### APPEAL SUMMARY

<b>Appeal ID:</b> 16170	<b>Project Address:</b> 621 SW Alder St, Unit #700
<b>Hearing Date:</b> 11/22/17	<b>Appellant Name:</b> Ivana Gazic
<b>Case No.:</b> B-008	<b>Appellant Phone:</b> 503-206-3814
<b>Appeal Type:</b> Building	<b>Plans Examiner/Inspector:</b> Steven Freeh
<b>Project Type:</b> commercial	<b>Stories:</b> 9 <b>Occupancy:</b> B <b>Construction Type:</b> I-A
<b>Building/Business Name:</b>	<b>Fire Sprinklers:</b> Yes - fully sprinklered
<b>Appeal Involves:</b> Alteration of an existing structure <b>LUR or Permit Application No.:</b> 17-254540-CO	
<b>Plan Submitted Option:</b> pdf [File 1] [File 2]	<b>Proposed use:</b> not given

**CKA OFFICE REMODEL**  
**7TH FLOOR - ELECTRIC BUILDING**

BUILDING CODE APPEAL

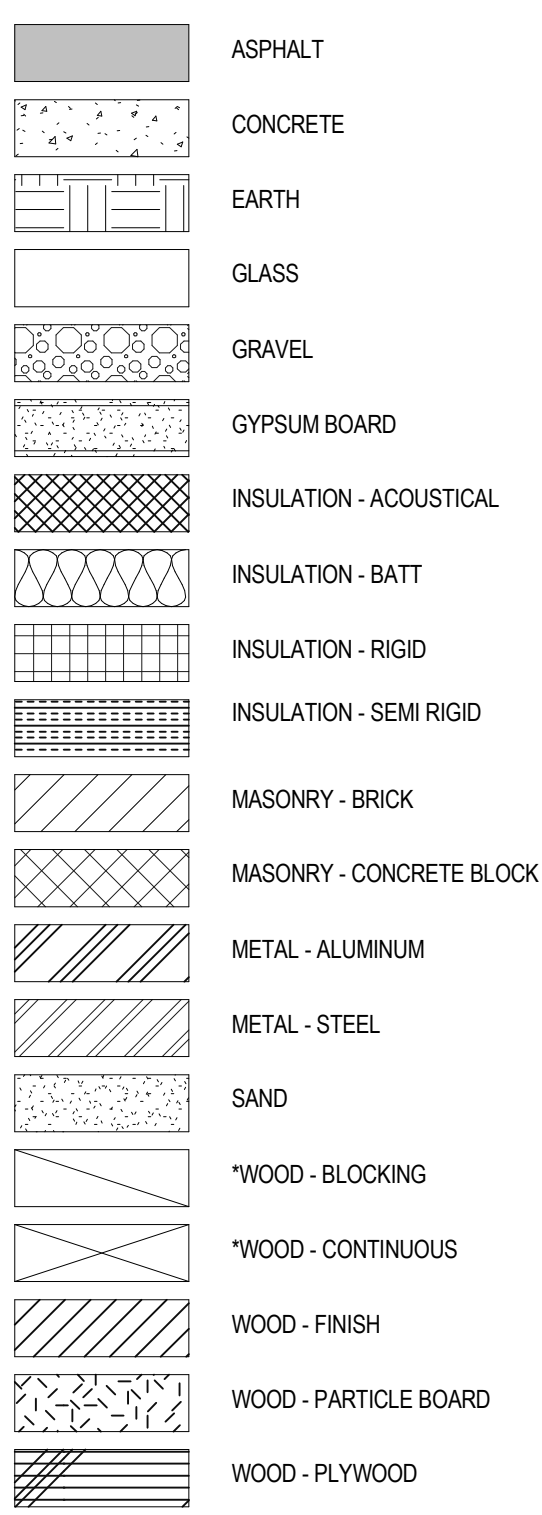
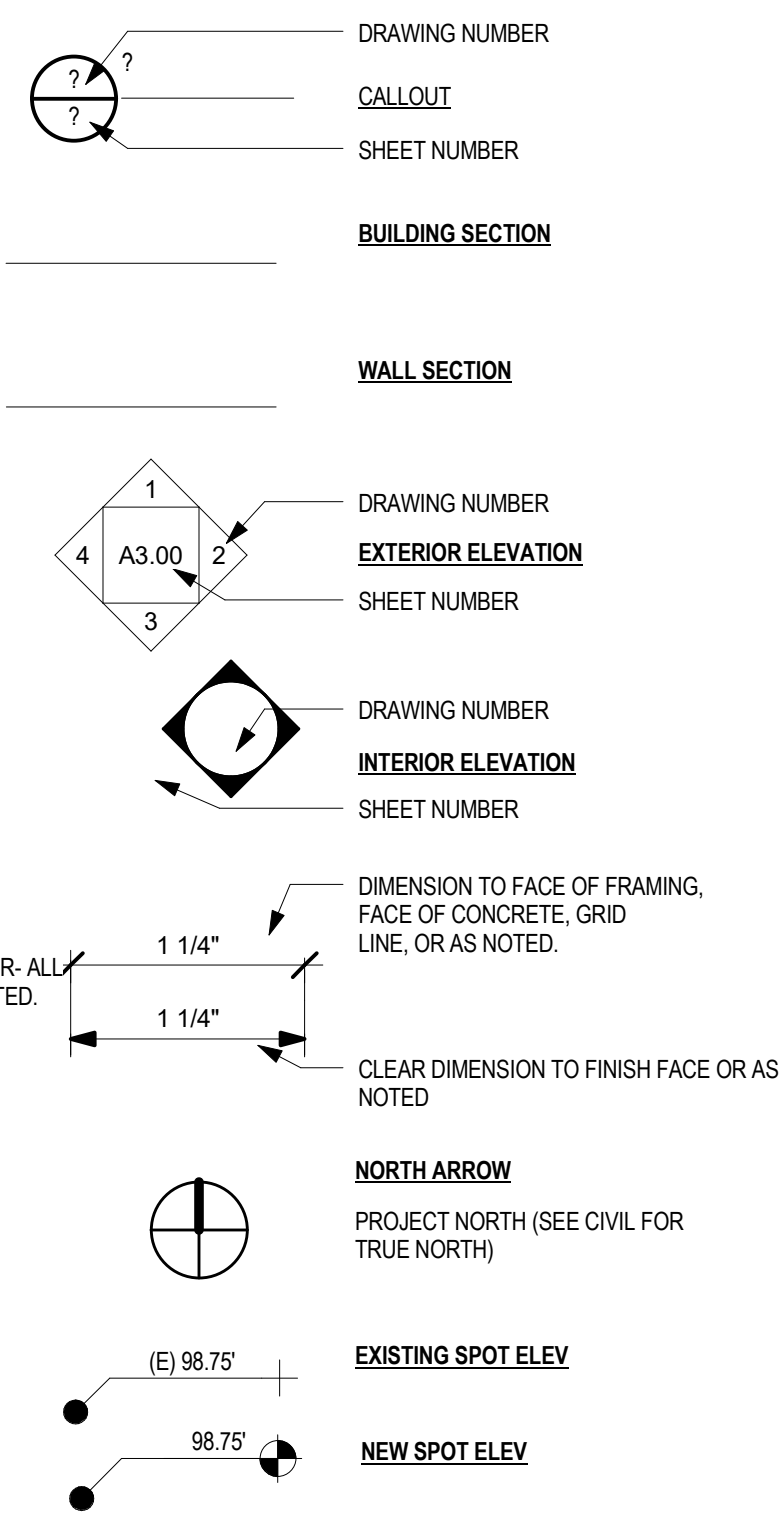
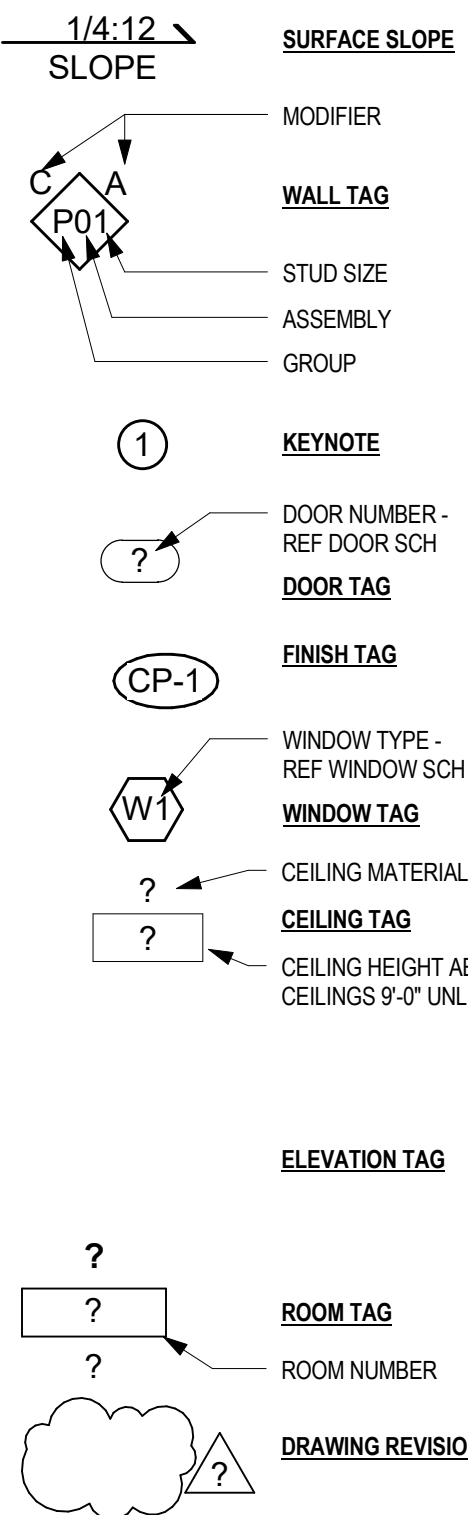
**Code Section** OSSC713.14.1; Table 716.5

**Requires** Minimum fire rating for the elevator lobby enclosure walls is 1 HR (OSSC713.14.1)  
Minimum door assembly rating for the elevator lobby door is 20 minutes (OSSC Table 716.5)

**Proposed Design** The proposed design consists of 1-HR fire rated partition walls (P84) and 1/2" tempered glass at Door # 722 and at the new windows into the office space. In place of the fire rated doors and windows, we propose a deluge sprinkler wall wash system installed to the satisfaction of the Fire Marshal's Office on either side of the glass door (#722) and the new windows (see attached plan A4.01). This "water curtain" system is described in the National Fire Protection Association (NFPA) Standard No. 13, Section 5-3.7 and 4-13.14.1 to protect proposed non-fire rated door construction in an exit-access doorway. In addition, silicone smoke gasketing will be installed on all edges of glass door and at glass panel joints.

**1. Sprinkler curtain in lieu of 1 hour rated openings in elevator lobby: Granted provided sprinklers are installed per the Fire Marshal's office and are capable of wetting the entire surface. A separate permit from the Fire Marshal's Office is required.**
